**AGENDA**  
**DESIGN REVIEW COMMITTEE**  
Lakeland City Hall, City Commission Chambers  
December 18, 2025  
immediately following the Historic Preservation Board Meeting

**HISTORIC PRESERVATION BOARD  
DESIGN REVIEW COMMITTEE  
STAFF REPORT  
December 18, 2025**

<b>Project #</b>	<b>HPB25-195</b>
<b>Project Type</b>	<b>Minor Exterior Alteration</b>
<b>Property Address; Historic Name</b>	<b>1926 Cherokee Trail / Fussell-Trohn House</b>
<b>Historic District; FMSF#</b>	<b>Beacon Hill; #PO02646</b>
<b>Owner/Applicant</b>	<b>Jeffrey and Megan Lazenby / ValuePro Remodeling &amp; Maintenance</b>
<b>Zoning; Future Land Use; Context District; SPI</b>	<b>Residential Medium; RA-1; Urban Neighborhood; None</b>
<b>Existing Use</b>	<b>Residential</b>
<b>Adjacent Properties</b>	<b>Residential</b>
<b>Previous Approvals</b>	<b>Window Replacement, 4/26/2018 (HPB18-066); Pool, 3/16/2022 (HPB22-059)</b>

<b>Project #</b>	<b>HPB25-218</b>
<b>Address; Historic Name</b>	<b>1056 South Boulevard; William and Myrtle Carpenter House (1924 CD)</b>
<b>Owner/Applicant</b>	<b>Alexa Lashkajani / Alan DeZayas, Avon Modular LLC</b>
<b>Project Type</b>	<b>Building Addition, Replacement Windows,</b>
<b>Historic Di

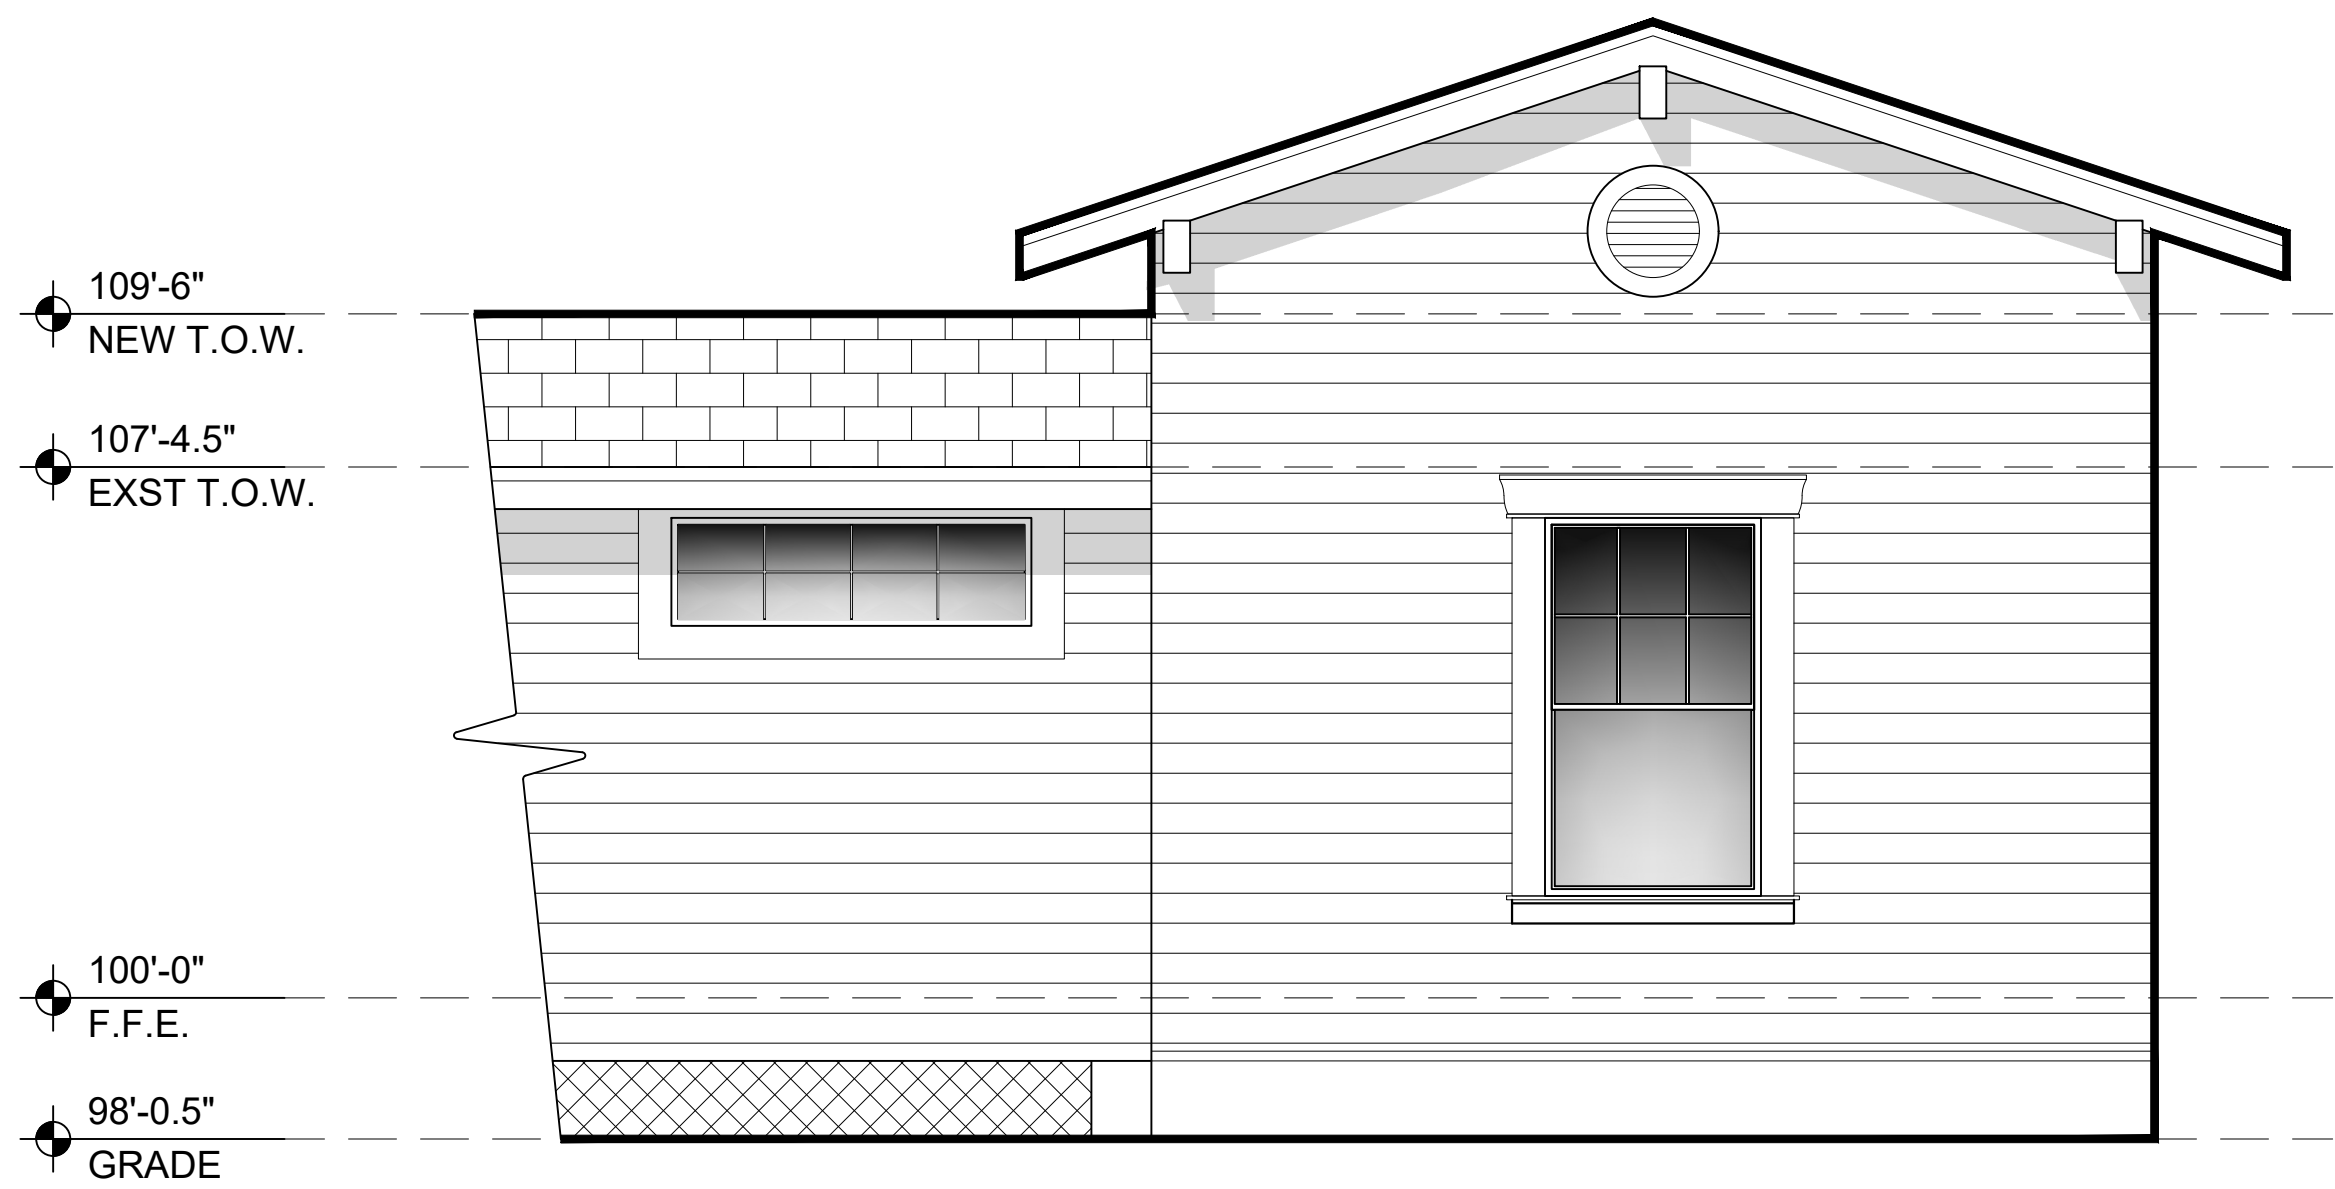
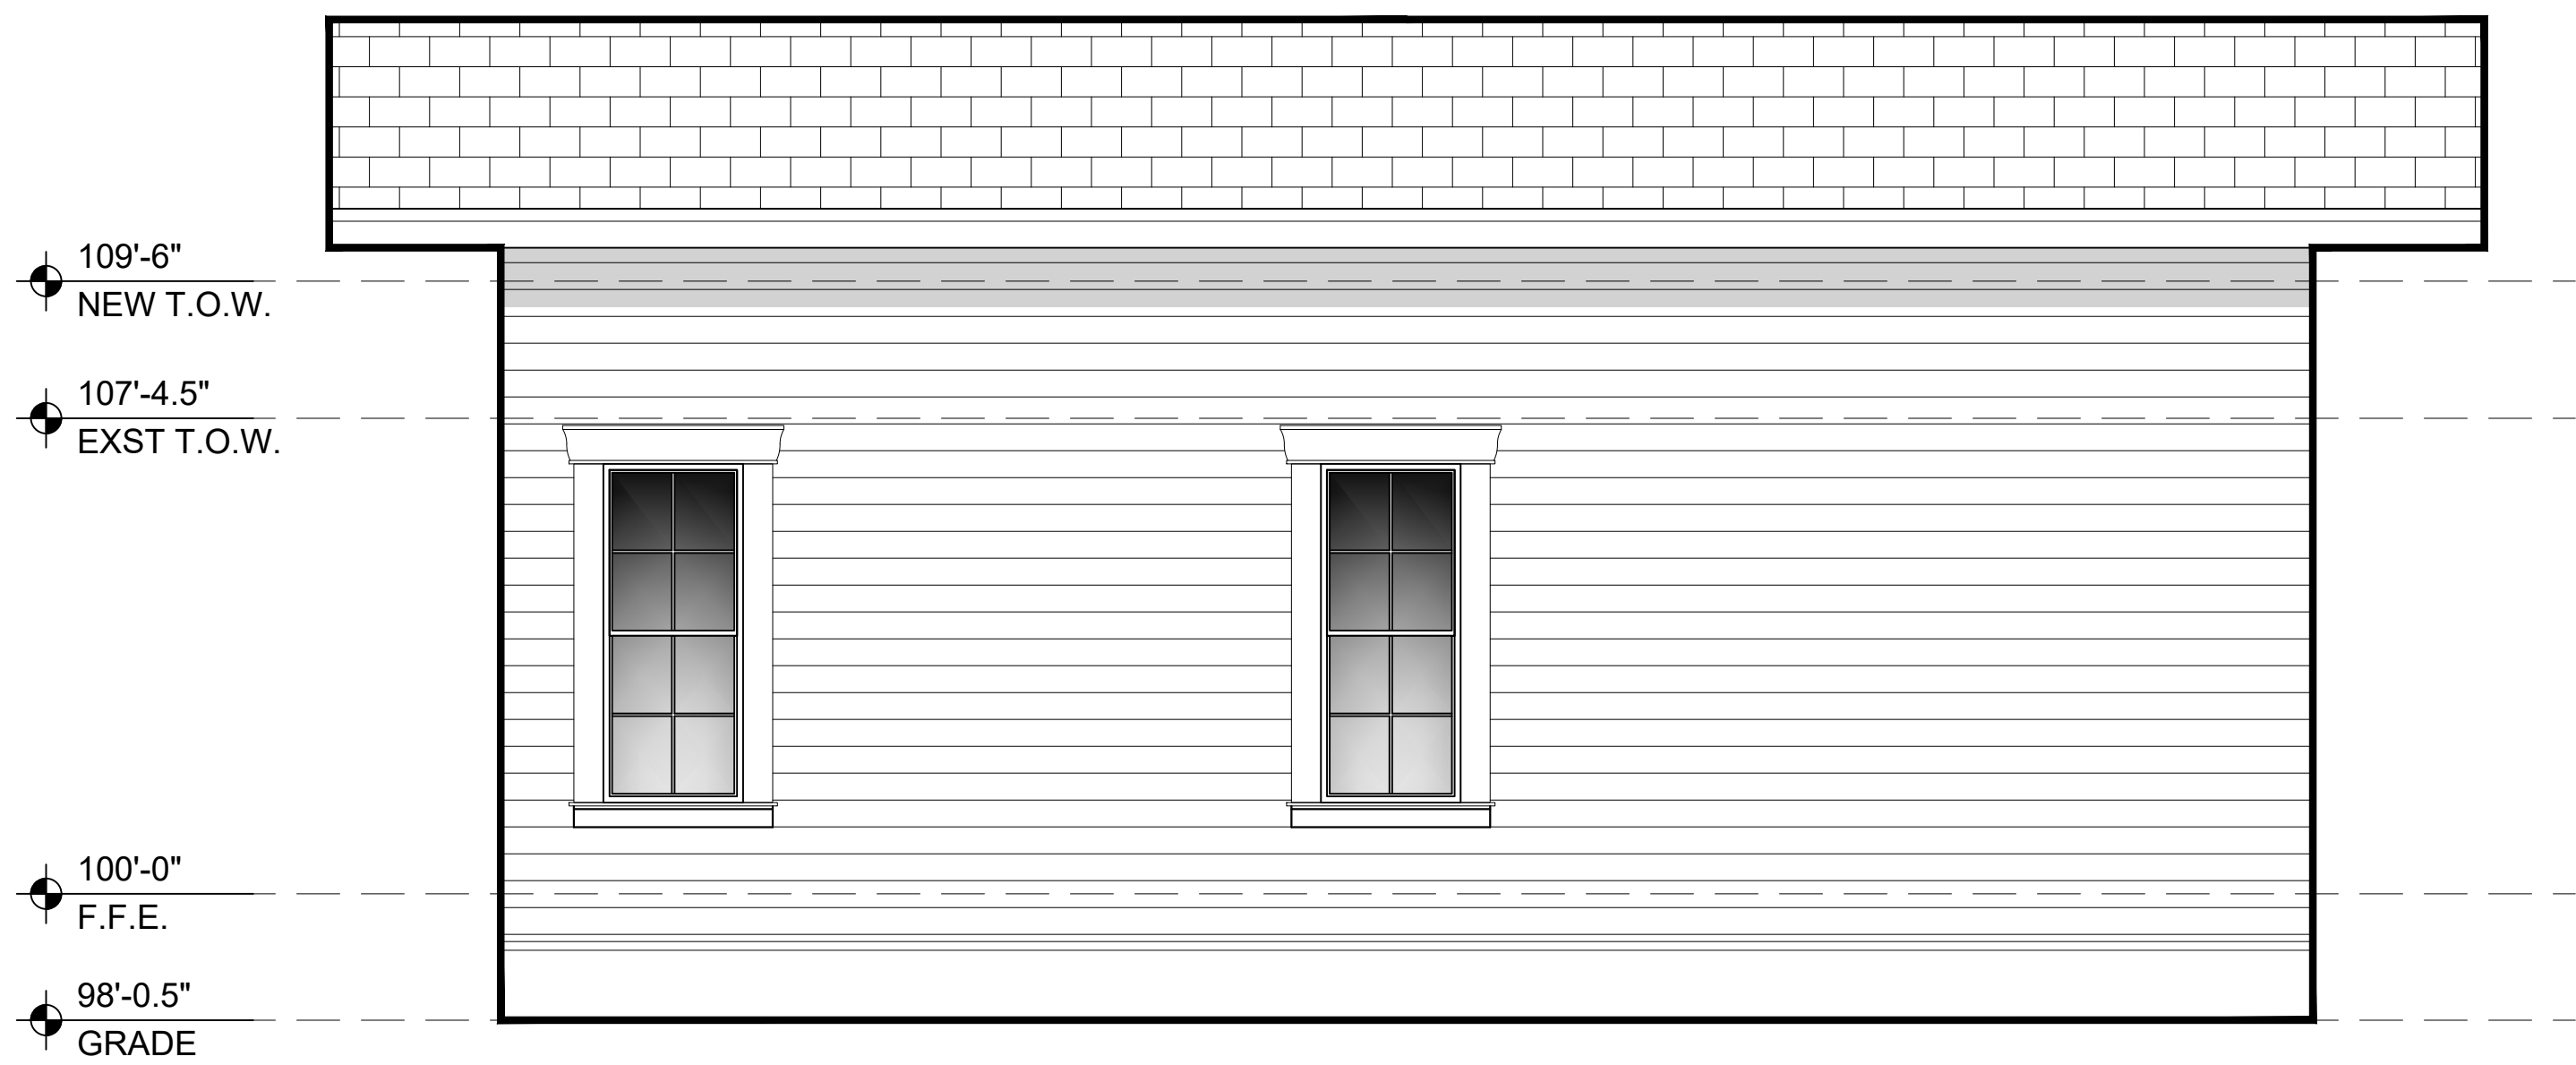
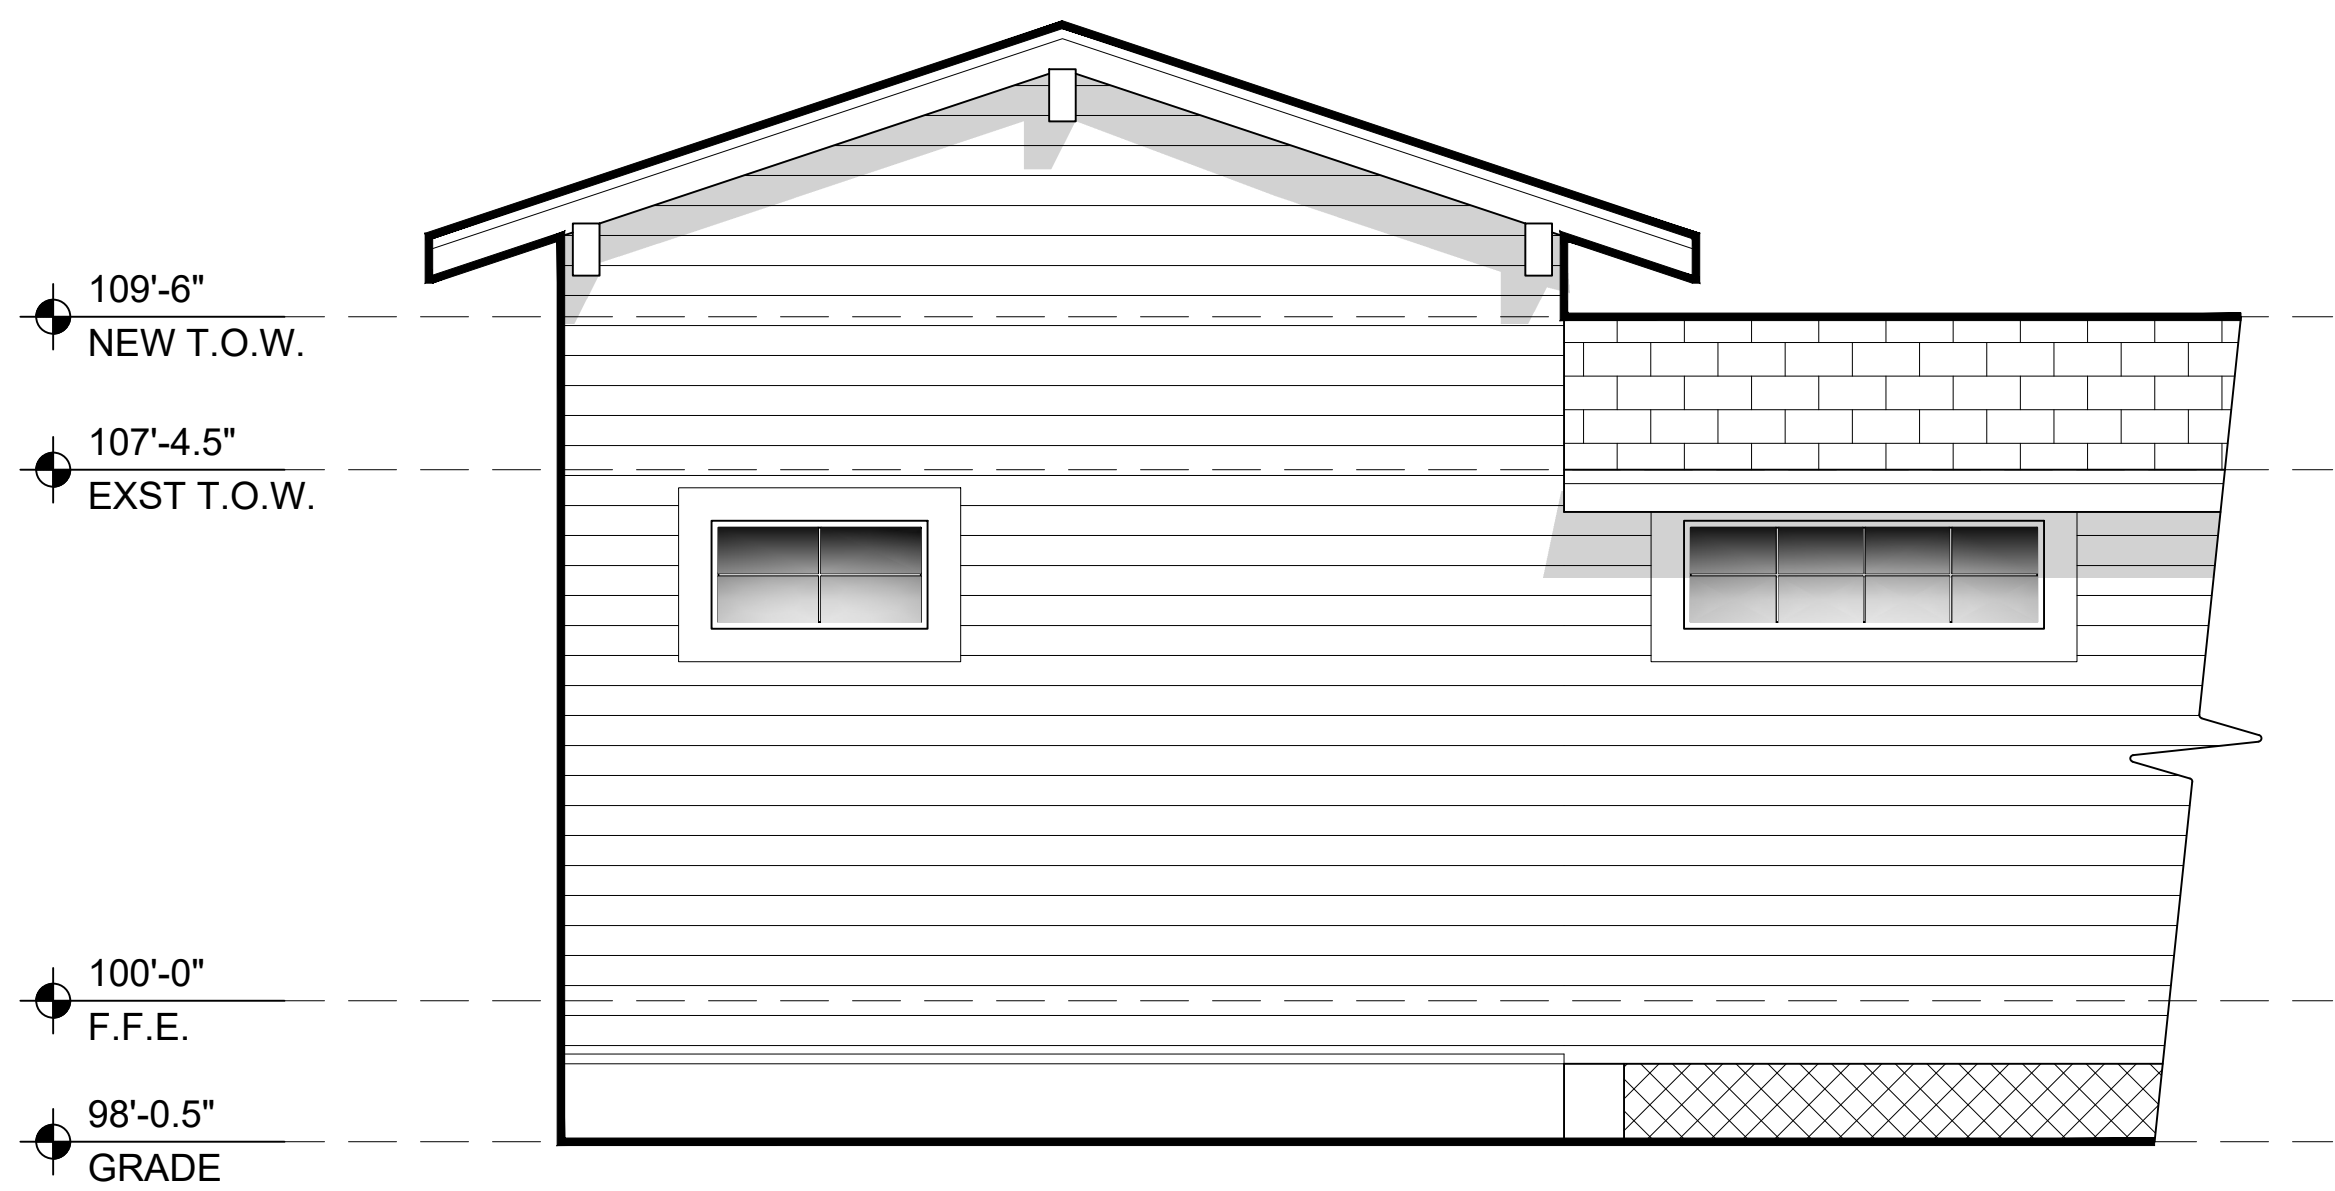
Regarding the request for the addition, staff finds the requested addition is consistent with the Standards as it does not disturb the spatial relationships that characterize the house, and the essential form and integrity of the subject house is maintained. The new addition is differentiated from the house by its subordinate massing and perpendicular orientation, which is similar to the orientation of the detached garage to be demolished. However, for further differentiation from the house, staff recommends not using a simulated divided lite appearance on the building addition's windows, especially as the addition is located at the rear of the property and will not be highly visible from the street. Additionally, the proposed simulated divided lite configuration of the windows on the addition are not consistent with the divided lite configuration of the home's historic windows.

In evaluating the proposed addition with the Design Guidelines, the materials of the and addition reflect the materials of the existing house and meet the intent of the Design Guidelines. The scale of proposed

addition's windows, wall cladding, and roof pitch and form is consistent with the Craftsman Bungalow style of the subject house. Furthermore, the addition is appropriately placed on the rear elevation of the house.

Regarding the request for replacement windows, typically, this type of request can receive approval under Minor Review (staff-level review) if the request is justified and complies with the Standards and Design Guidelines. Historic windows are character-defining features of a historic building, and the removal of repairable historic windows and installation of inappropriate replacement windows can adversely affect the architectural integrity of a building. As the request is not consistent with the Standards and Design Guidelines, and staff was not provided adequate evidence to show that the historic windows are deteriorated beyond reasonable repair, this request could not be approved at the Minor Review level. Additionally, the proposed replacement windows do not match the divided lite appearance of the historic double-hung sash (9-over-1 and 9-over-9 lite configuration) and casement (9-lite configuration) windows. For these reasons, staff recommends that the historic wood windows be repaired by a qualified window restoration professional instead of being replaced as requested.

1. Final Approval of the requested addition with the following conditions, to be reviewed and approved by staff prior to the issuance of a building permit:
  - a. Windows shall be recessed to provide a shadow line.
  - b. Windows shall not have a simulated divided lite appearance.
2. Denial of the request to replace the historic wood windows.
